Subject: SDP Contracts No. B-060C of 2018/19 General Construction

Location: Paul L. Dunbar Elementary School 1750 N. 12th Street Philadelphia, PA 19122

Addendum No. 1

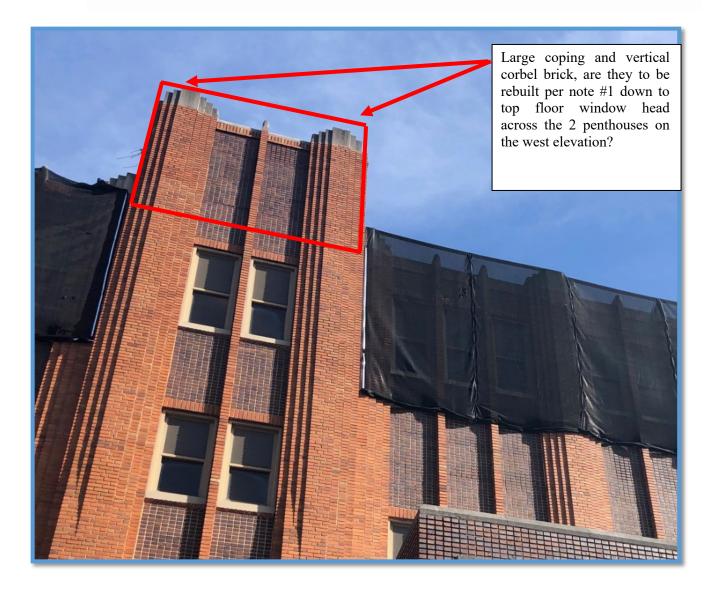
2. There is temporary overhead protection erected over the 2 back entrance ways. Will this remain, or is this going to be removed and we are responsible for putting our own up?

Response: The winning bidder shall coordinate with SDP to disassemble the existing temporary protection installed, return the materials to SDP, and install their own temporary protection as part of this contract.
